### **Amendments to the Drawings**

The attached replacement drawing sheet contains proposed amended Figure 8. No new matter has been added.

Figure 8

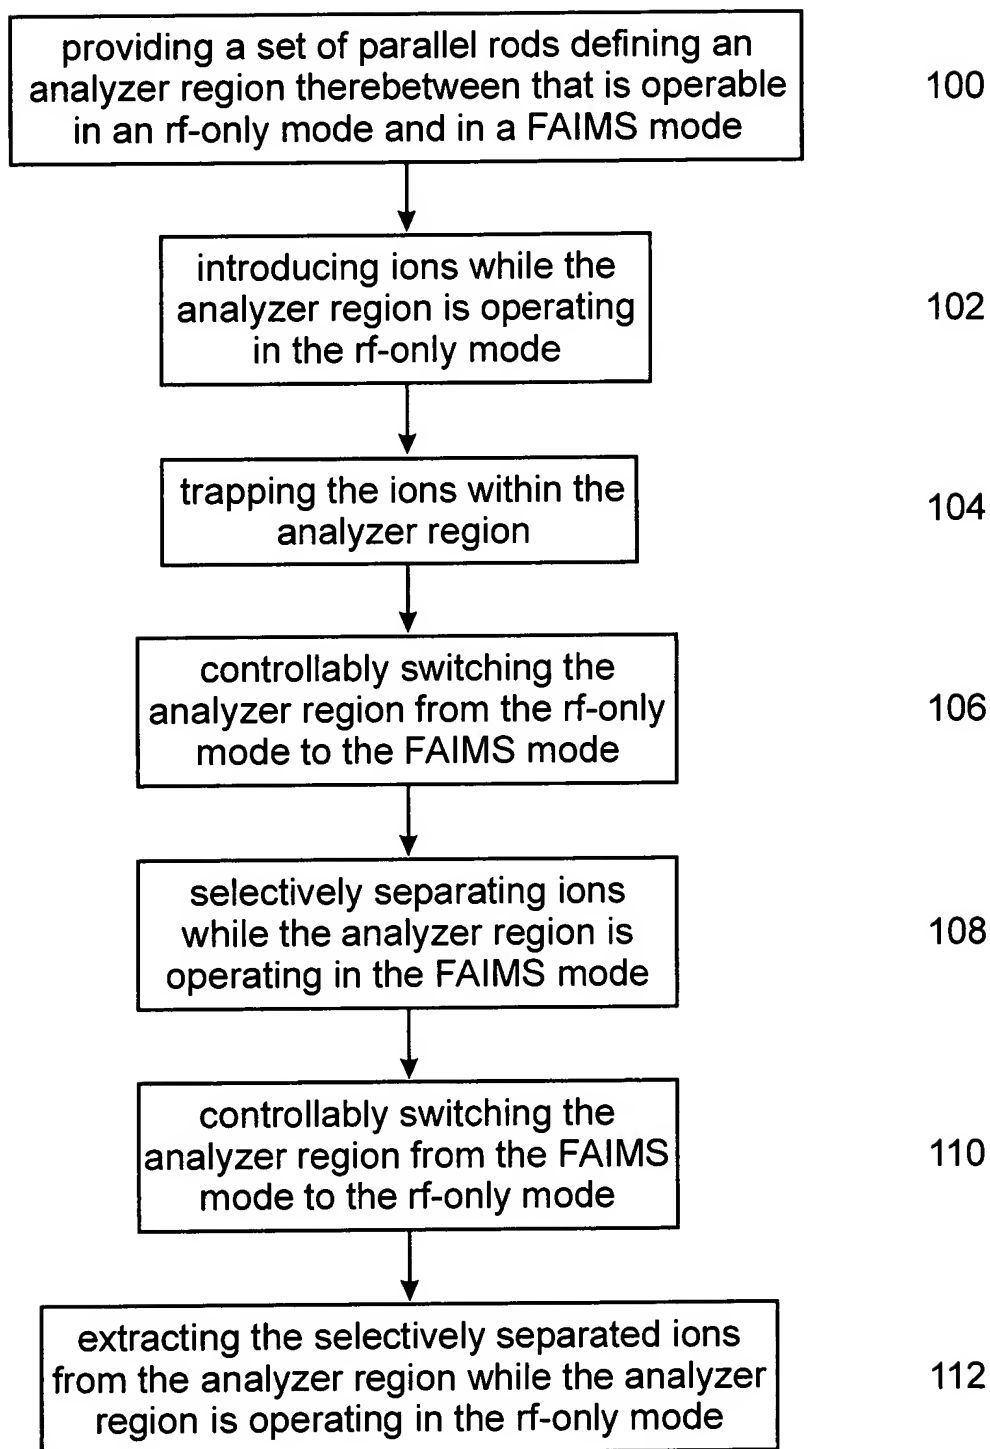
**Figure 8** has been amended at step 110. In particular, the text “controllably switching the analyzer region from the rf-only mode to the FAIMS mode” has been amended to read -- controllably switching the analyzer region from the FAIMS mode to the rf-only mode--. Applicant respectfully submits that the proposed amendment to Figure 8 merely corrects an error of a clerical nature, which arose out of inadvertence. In particular, when the drawing sheet containing Figure 8 was prepared, the text appearing at box 106 was copied to box 110, but was not modified to agree with text appearing at paragraph [0093] of the application as originally filed. No new matter has been added.
